CHILDREN'S HOSPITAL AND RESEARCH CENTER OAKLAND CAMPUS MASTER PLAN PROJECT RESPONSE TO COMMENTS DOCUMENT

STATE CLEARINGHOUSE NO. 2013072058

February 2015

The attached Figure RTC-V-3: Location of the Former LUST Sites, shows the location of the former UST, the predominant groundwater flow direction described in the March 2013 request for closure for the site,¹ and

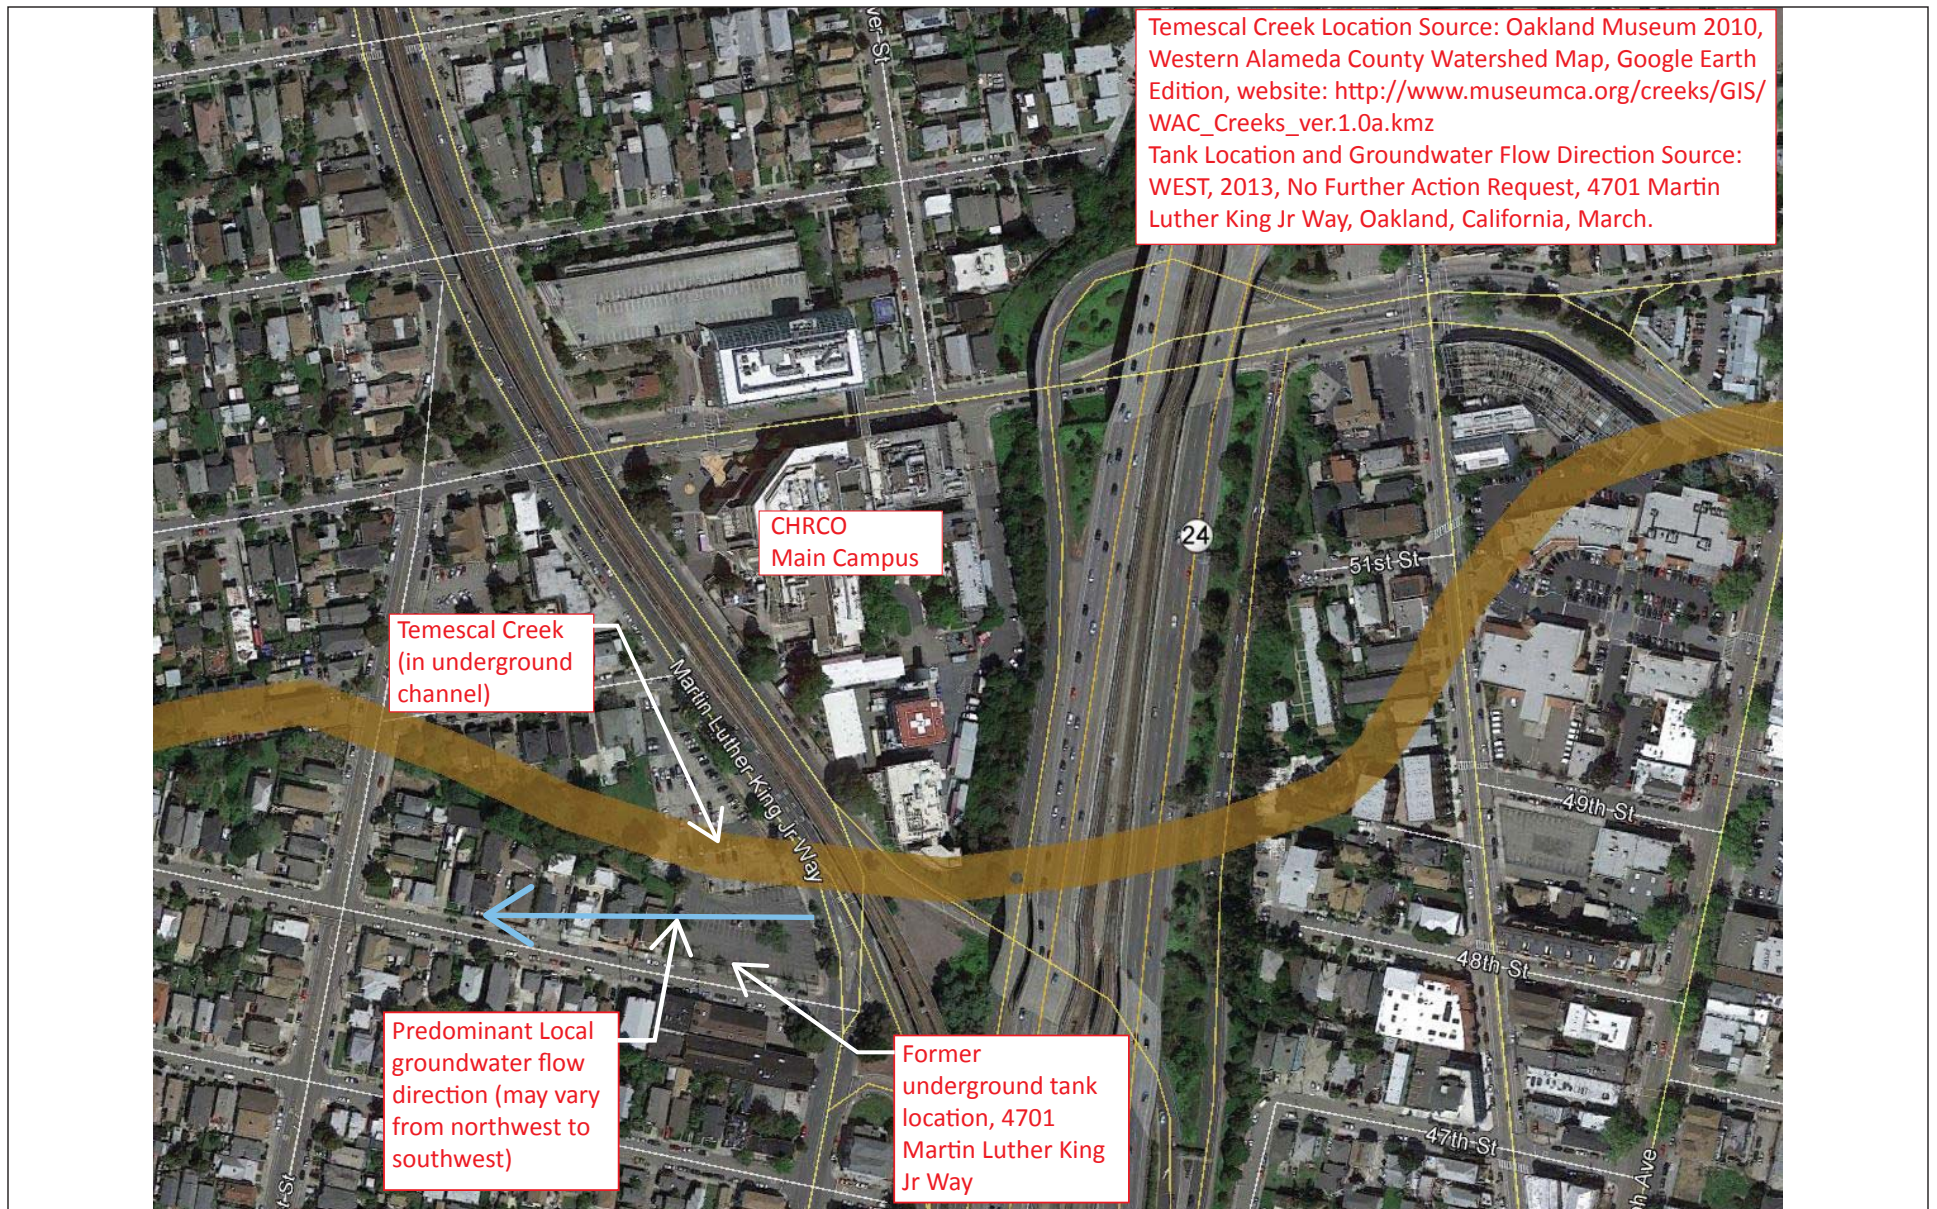
Response B2-4: The commenter states that releases from a former leaking underground storage tank (LUST) at 4701 Martin Luther King Jr. Way have resulted in significant soil contamination at the project site, that the Draft EIR states that the site has been adequately cleaned up, and that the most recent regulatory action at that site was to request additional information of contamination that may affect Temescal Creek. The commenter states that this contamination represents a significant impact to the project.

The commenter is incorrect that the project would result in impacts related to contamination from the 4701 Martin Luther King Jr. Way LUST site. As shown in Figure III-6 on page 76 of the Draft EIR, the LUST site, labeled as the CHRCO Annex Employee Parking Lot, is located across Martin Luther Jr. King Way, to the west of all proposed project construction areas, and no changes in current land use are proposed for the LUST site.
